FORD:

2017 Escape

ISSUE

Figure 1 - Article 17-0032

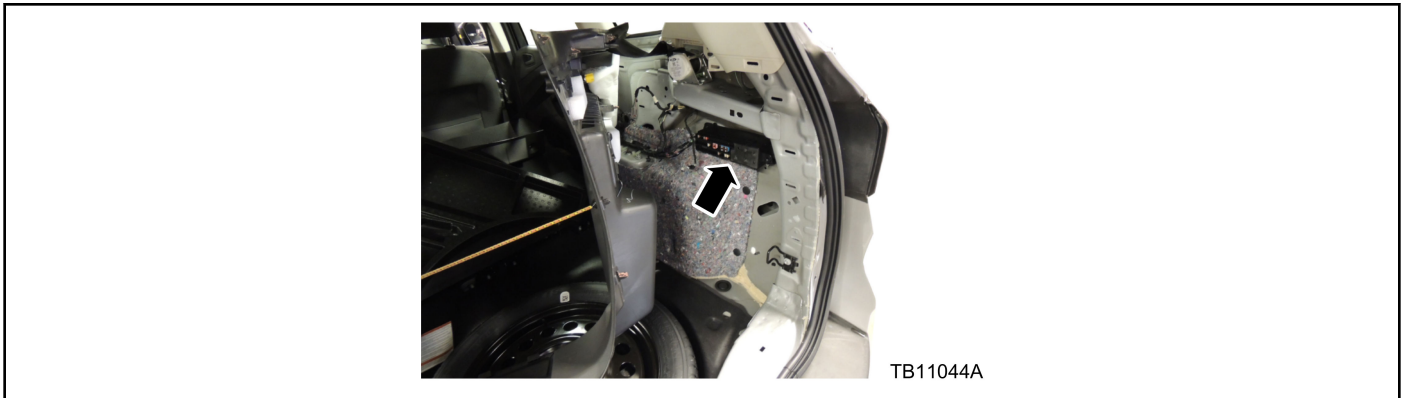
1. Check the vehicle build date. Was the vehicle built on or before 29-Jul-2016?
 - a. Yes - proceed to Step 2.
 - b. No - this article does not apply. Refer to Workshop Manual (WSM), Section 501-11.
2. Disconnect negative battery cable. Refer to WSM, Section 414-01.
3. Position the right side loadspace trim panel aside for access to the RJB. Refer to WSM, Section 501-05. (Figure 1)

- a. It is not necessary to remove the rear seats, right side rear door weather strip and right side rear door scuff plate trim panel.
4. Remove the nut securing the RJB and unhook the opposite end from the body.
5. Insert a small screwdriver in 3 slots and remove the relay cover from the RJB.
6. Document the location or photograph RJB fuses and relays. Remove all fuses and relays. Refer to Wiring Diagram, Cell 11.
 - a. Utilize the fuse removal tool if present in the underhood power distribution box (PDB) or appropriate fuse and relay removal tools.
7. Insert a screwdriver in 4 slots on the side of the RJB and push back the latches to release and remove the top cover from the RJB housing.

Figure 2 - Article 17-0032

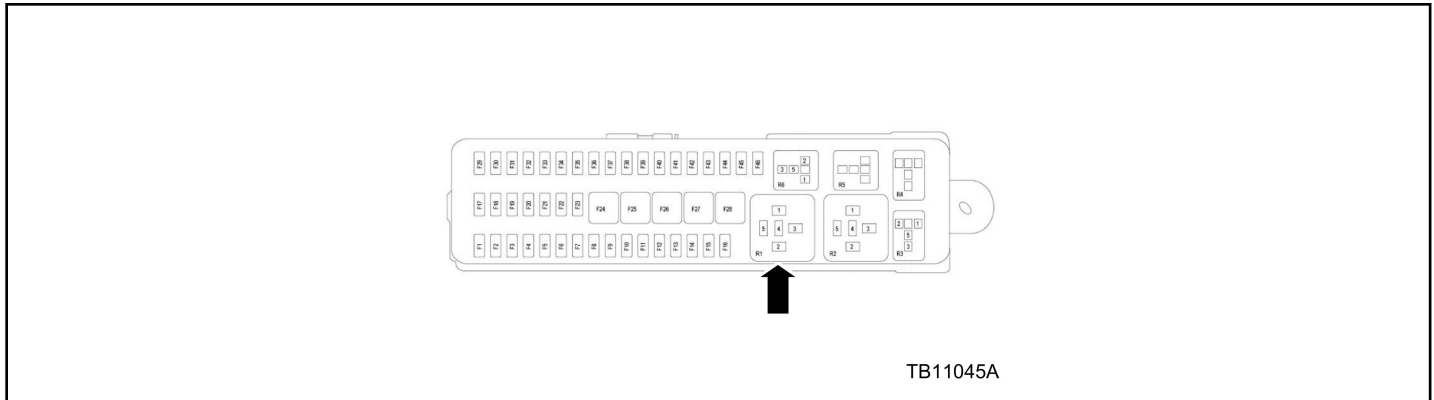
8. Cut the tie straps securing harness bundle to the RJB.
9. Locate the accessory delay relay output terminal 5 in the RJB and using a pick or suitable tool remove circuit CDC40 VT/GY wire. Refer to Wiring Diagram, Cell 11 and 13. (Figure 2)

13. Locate RJB fuse 15 circuit SBR15 WH/RD and using a pick or suitable tool, remove circuit SBR15 WH/RD wire from the RJB. Refer to Wiring Diagram, Cell 11 and 13. (Figure 2)

16. Install the VT/GY female terminal on the service pigtail into the accessory delay relay output terminal 5 in the RJB. Refer to Wiring Diagram, Cell 11 and 13. (Figure 2)
